Administrative Amendment for City of Albuquerque permit #BP-2020-27106

Re: McDonald's 4300 Osuna Rd. NE (PR 2020-004189)

RE: Amendment to Site Development Plan
McDonald's Restaurant – 4300 Osuna Rd. NE

V-NOTCH CONCRETE SWALE IN GRASS AREA
NOT TO SCALE

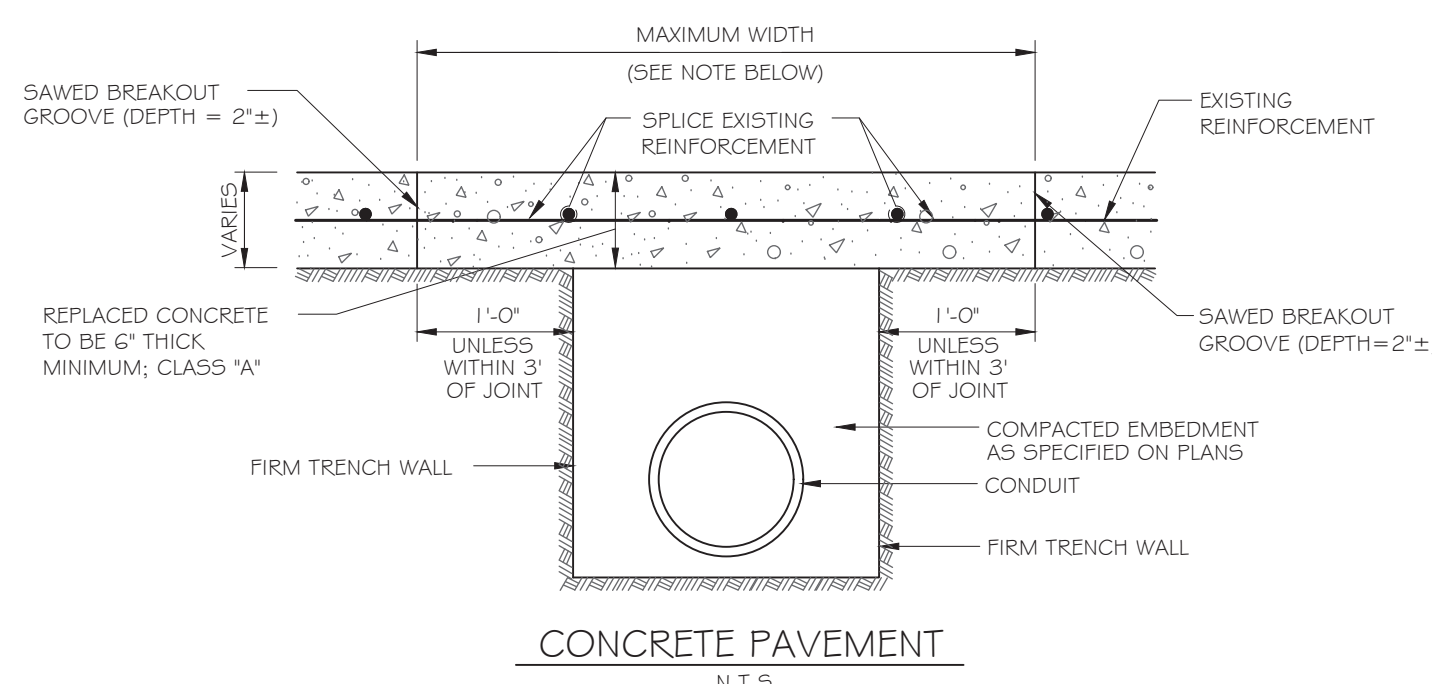
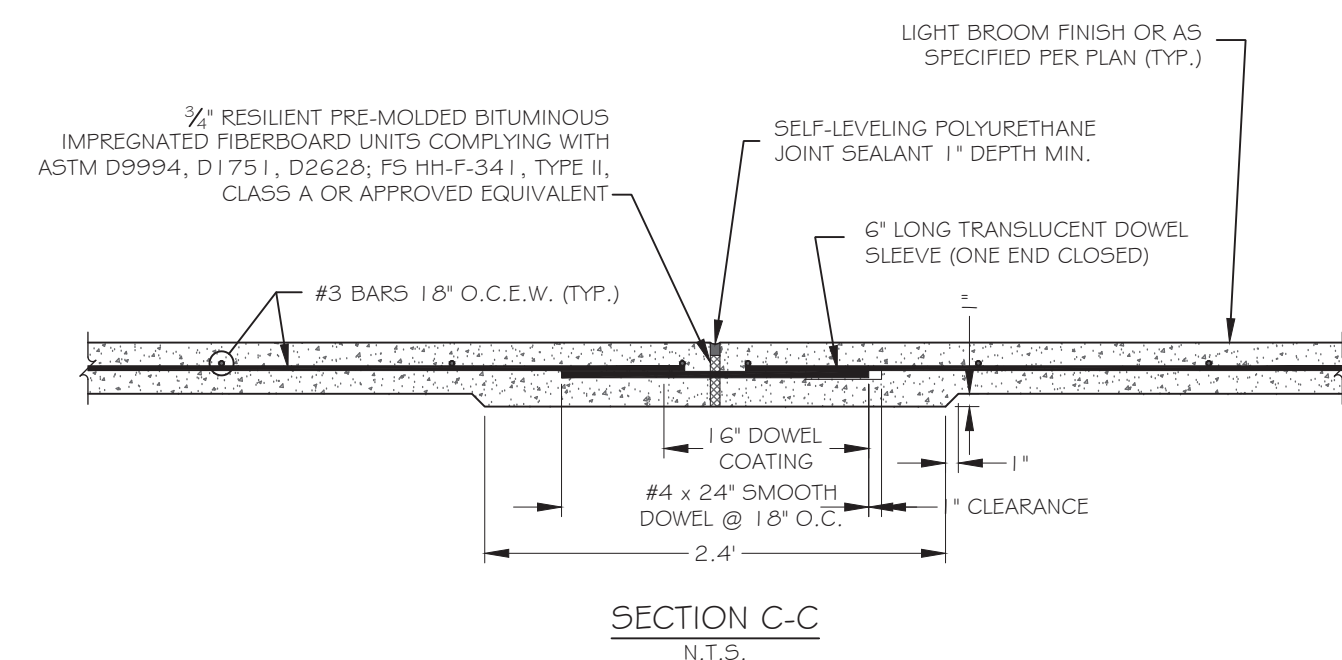
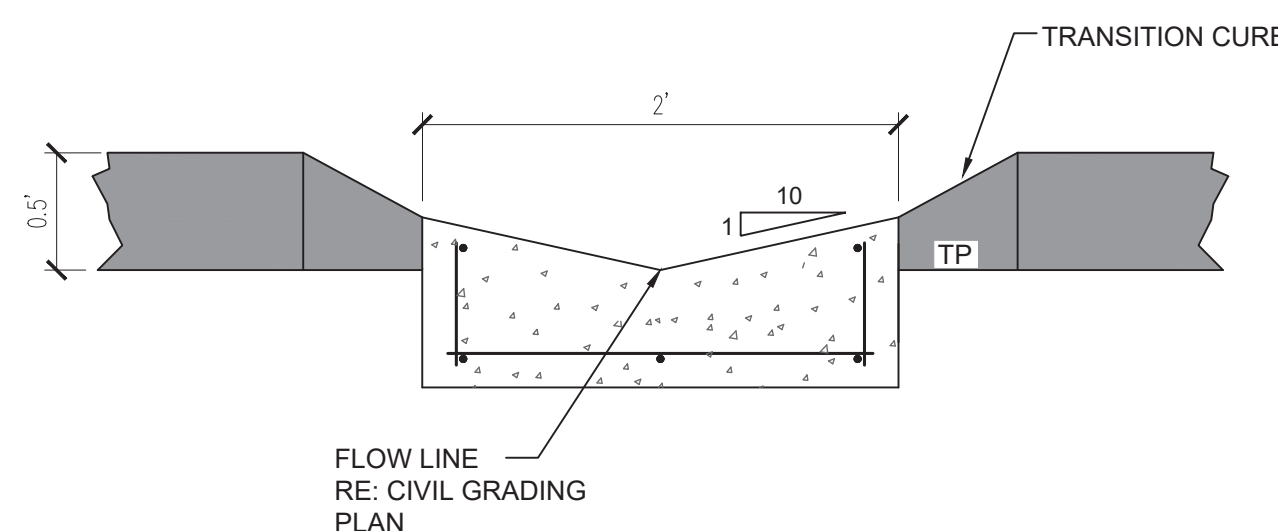
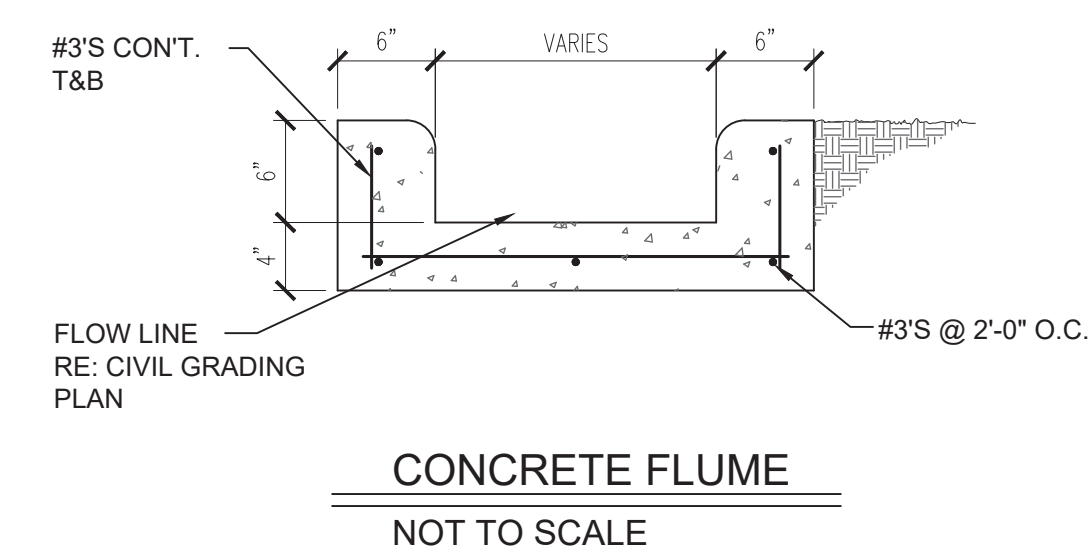
- An 11' wide van accessible space with a 5' aisle are shown in accordance with ADA Standards 502.2 and 502.3.1. See C3.0 Site & Paving Plan.
5. Include C7.1, C7.3 and C7.5 standard details as part of this set. All details for curb, sidewalk, curb ramps, and signage have to be included.

- Detail sheets have been included.
6. The ADA accessible parking sign must have the required language per 66-7-352.4C NMSA 1978 **"Violators Are Subject to a Fine and/or Towing."** Provide detail of sign.
